Planning Applications Committee
24 August 2023
Modifications Sheet

ITEM 5 (565 KINGSTON ROAD, RAYNES PARK SW20 8SA)

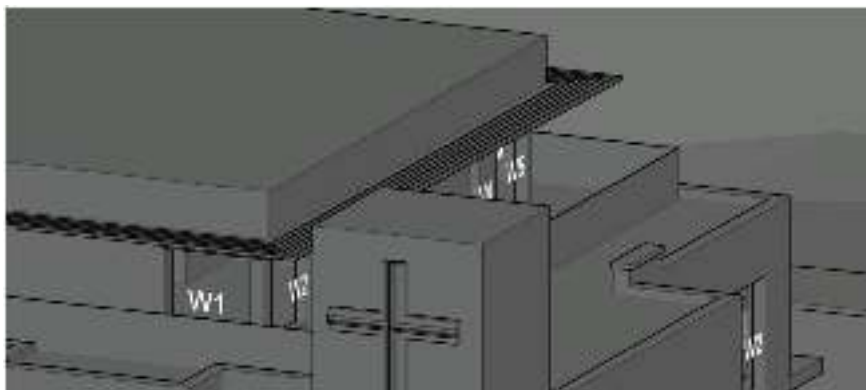
28, In their representations apartment 16, 577a Kingston road state the light loss in living area and not the bedroom. Can you confirm?

Yes, the affected room is a living area and is assessed as such in the report. It is true that the report creates confusion by wrongly referring to bedrooms in a later paragraph.

This is a penthouse apartment with abundant light and the impact on this room is very low. It is set back from the boundary. It restricts its own daylight due to the overhang – see below.
